Preliminary Findings from Review

of the USGS Study of the
Cuyama Valley Groundwater Basin

Cuyama Basin Water District

27 October 2017 | EKI B70069.00

Figure 8g

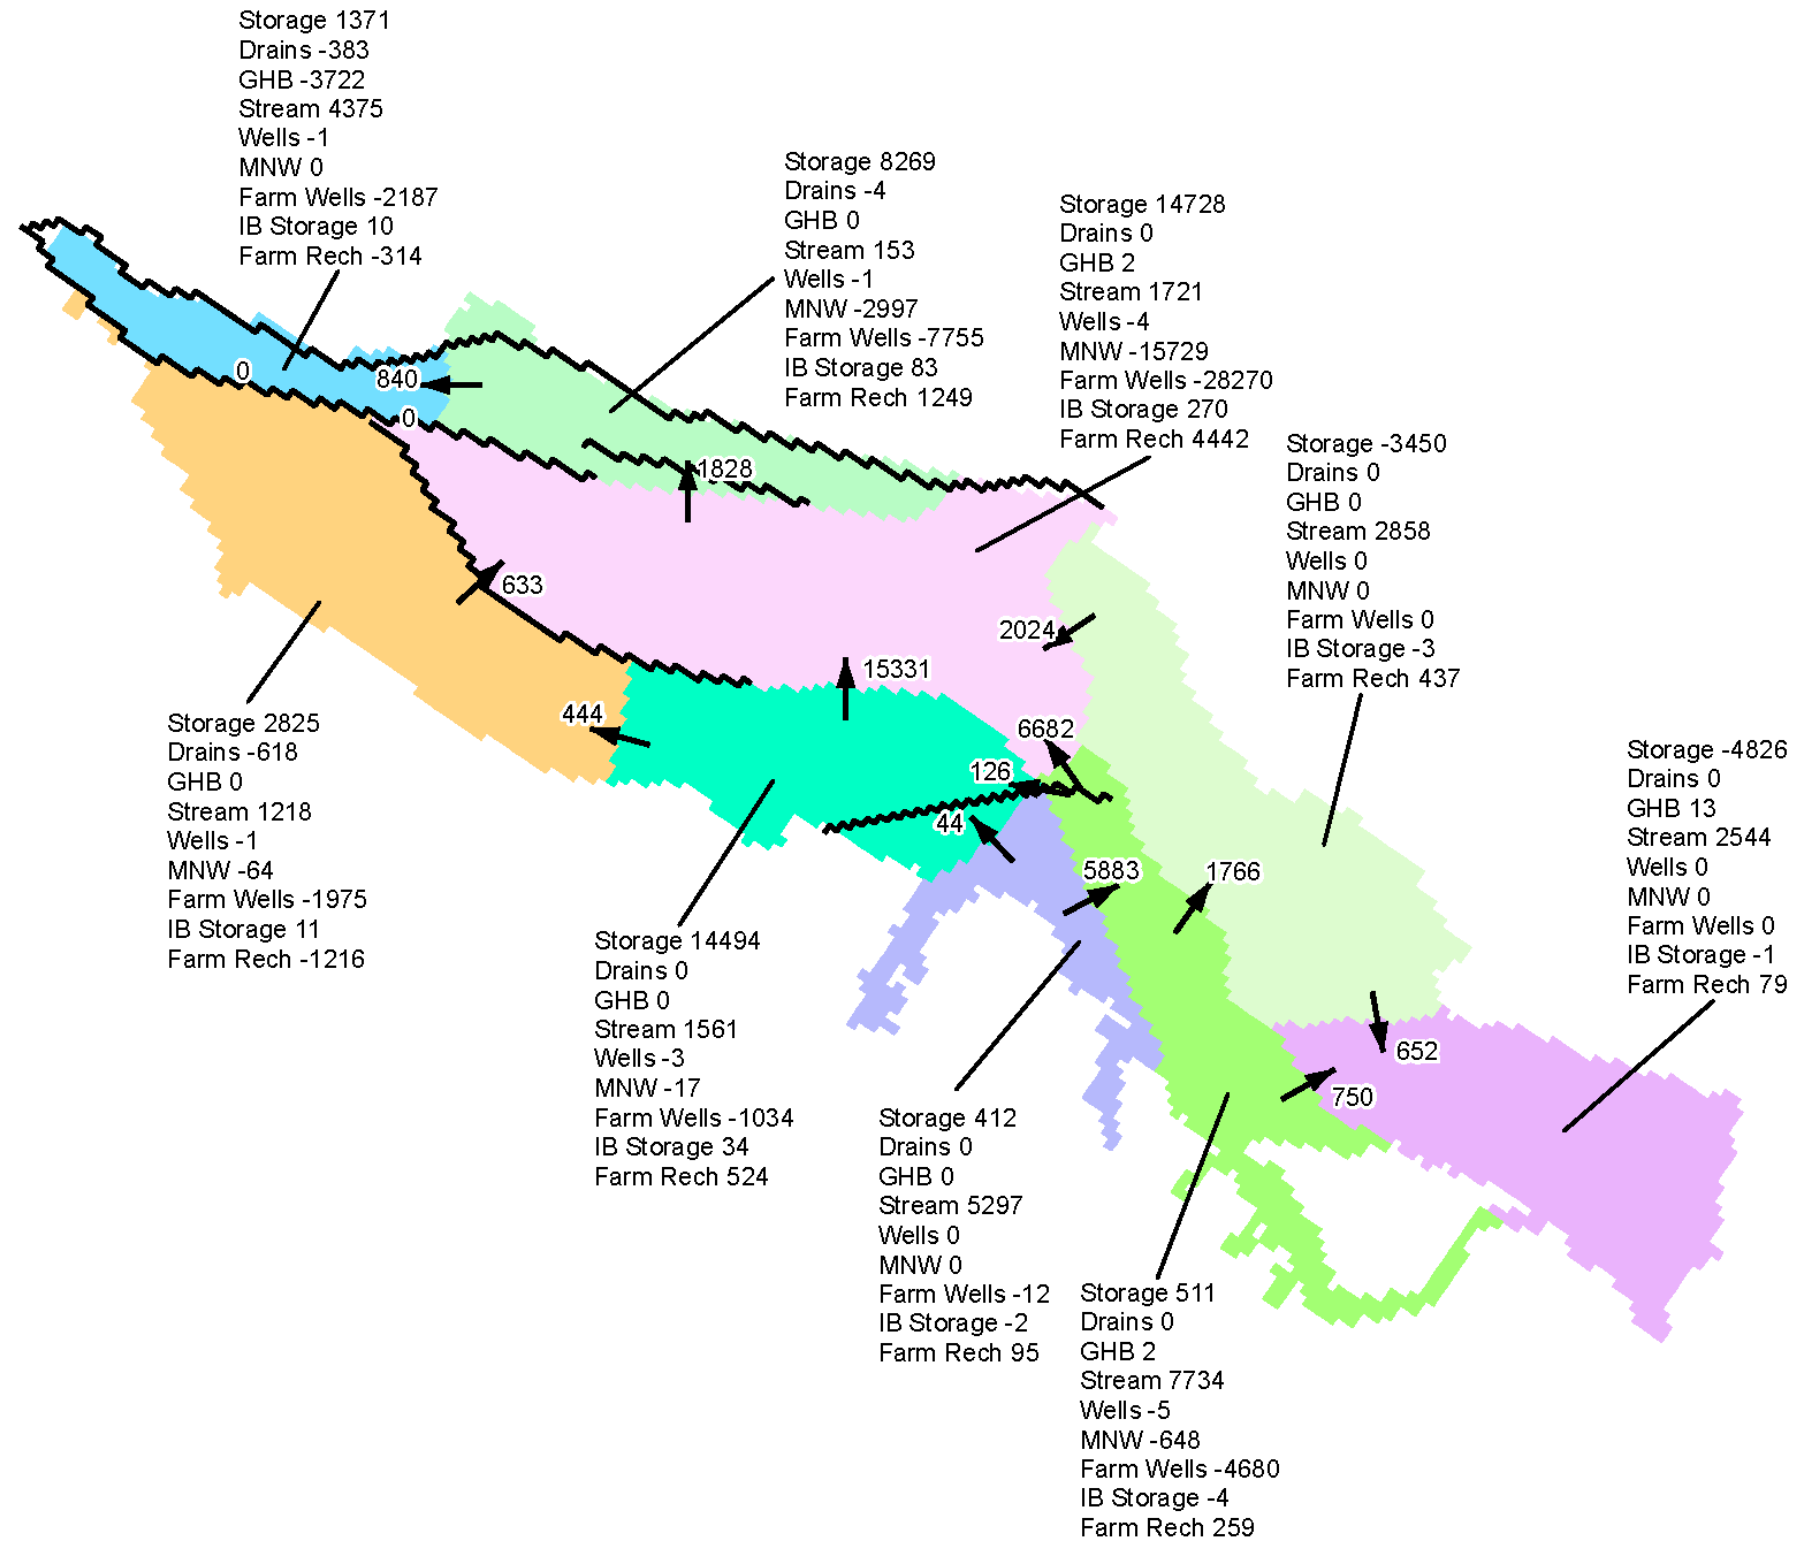
Plotting the stable isotopes of oxygen (^{18}O) and hydrogen (^2H) by zone shows very little distinction in stable isotope ratios between zones (see Figure 8g). There does appear to be a tendency for samples collected from the Ventucopa Uplands zone to plot on the “lighter” side of the stable isotope graph (i.e., bottom left), suggesting that this zone receives a greater proportion of recharge from the Cuyama River. This is consistent with the USGS conceptualization of the basin, where the southeastern portion of the basin is shallower and generally exhibits greater hydraulic connectivity to the Cuyama River. However, significant variability exists for samples collected from the Main and the Sierra Madre Foothills zones, indicating that there is no readily discernable trend or distinction in the proportions of recharge sources entering these hydrologic zones. Rather, the variability in stable isotopes within these zones suggests there are significant local complexities in contributing recharge patterns as opposed to general “subregional” or “subzonal” trends.

USGS Model Water Budget by Study Area Subregion – Base Case

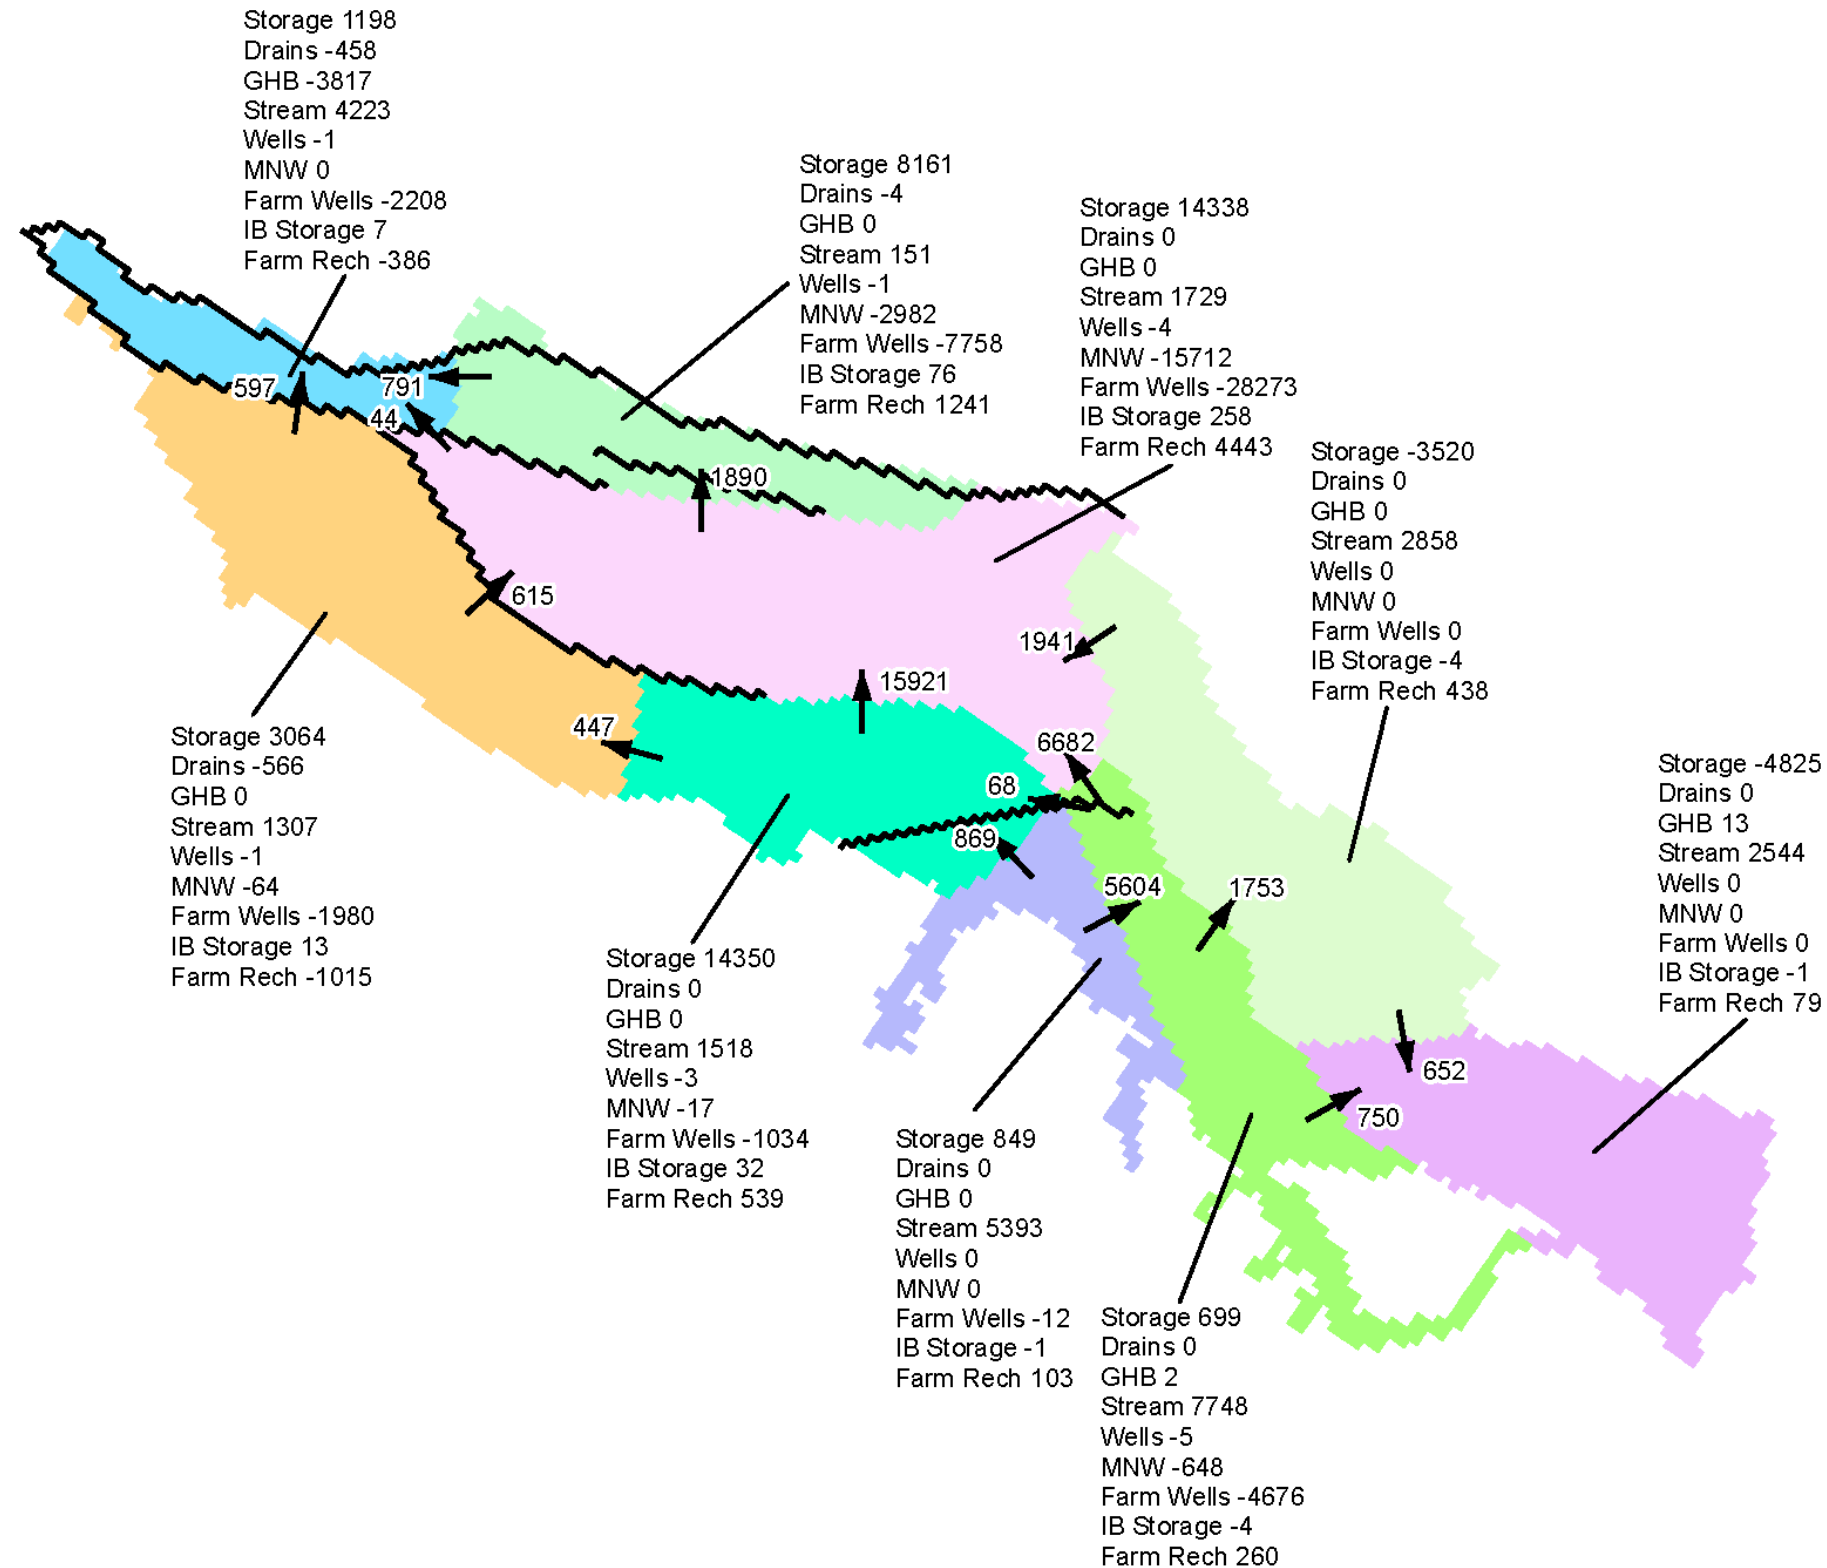
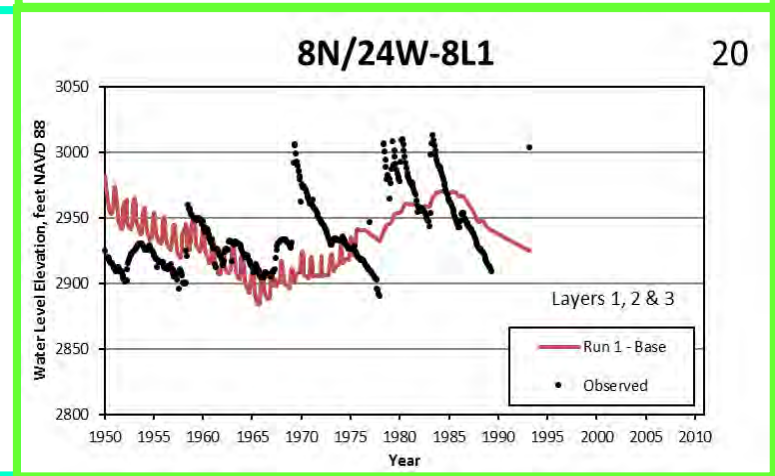
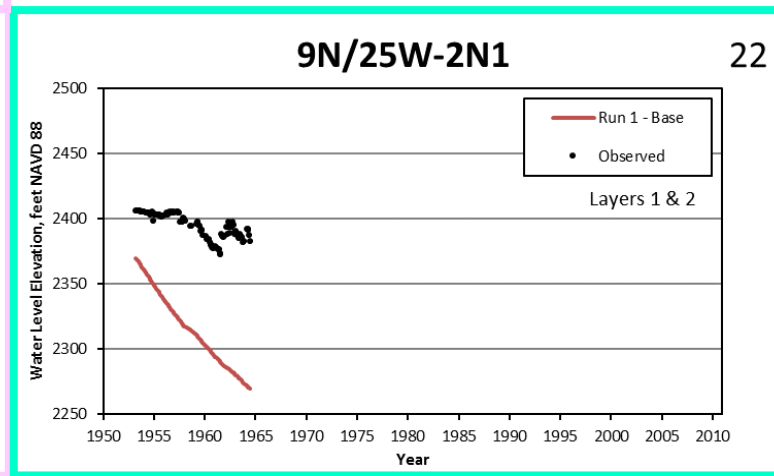
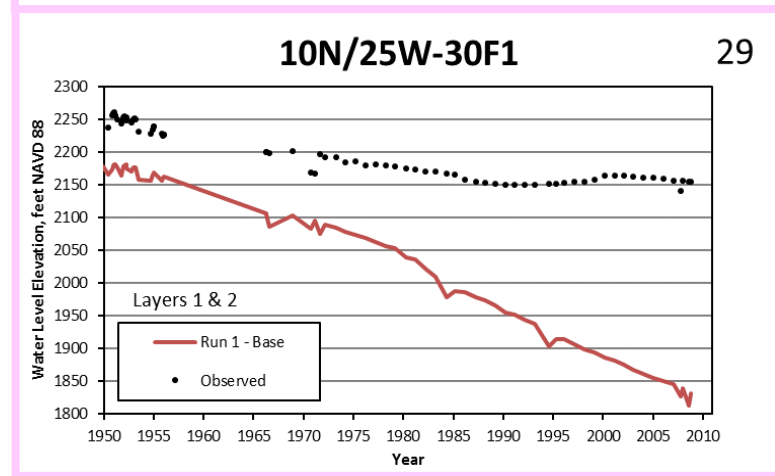
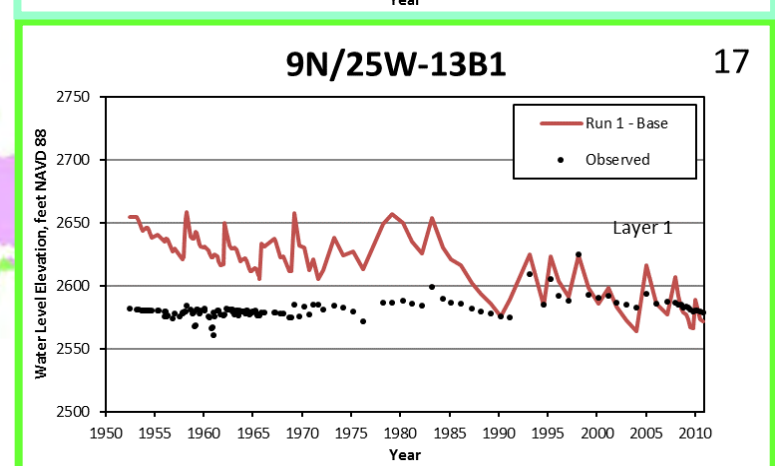
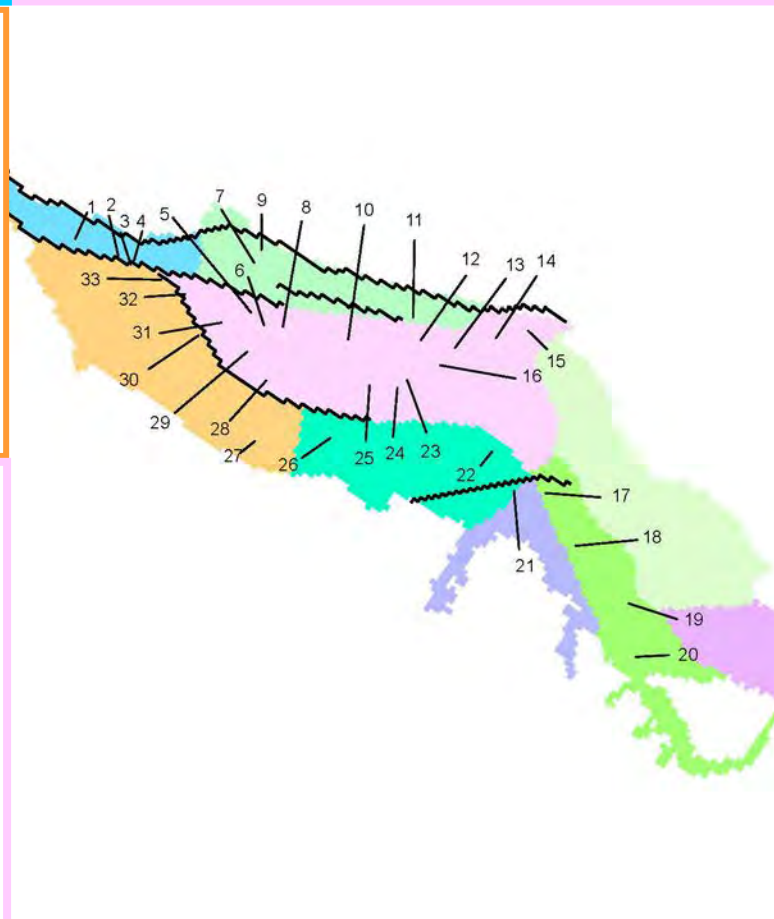
The EKI Team tested the sensitivity of the CUVHM results and the water budget by increasing modeled fault conductivity by six to nine orders of magnitude²². Table 2c shows the percentage change in the magnitude of subregional water budget components between the “Base” model run (Figure 9a, Table 2a) and the “Increased Fault Conductance” model run (Figure 9b, Table 2b). As expected, increasing the fault conductance affected the subsurface flux rates between some of the subregions that share an affected fault boundary, notably across the Santa Barbara Canyon fault (i.e., where an 1875%, or 825 AFY increase was observed) and the Turkey Trap Ridge fault

(i.e., where an 100%, or 597 AFY increase was observed). However, in some cases the flux remained surprisingly unchanged, even with an increased fault conductance. We also noted that certain other subregional water budget components that are driven by simulated groundwater levels (e.g., flux from “storage” and “Farm Recharge”) were affected by the change in fault conductance values, suggesting that determination of these sub-regional water budgets through numerical modeling is in some cases non-intuitively driven by the uncertainty in boundary definitions.

- The CUVHM calculates approximately 650 AFY and 750 AFY of subsurface inflows to the Northeast Ventucopa Uplands from the Northern and Southern Ventucopa Uplands subregions, respectively (see Figures 9a and 9b), despite the fact that this area is higher in elevation and upgradient of the two adjacent Ventucopa Uplands subregions (see Figure 8d). There is no data to confirm this seemingly anomalous water budget output.
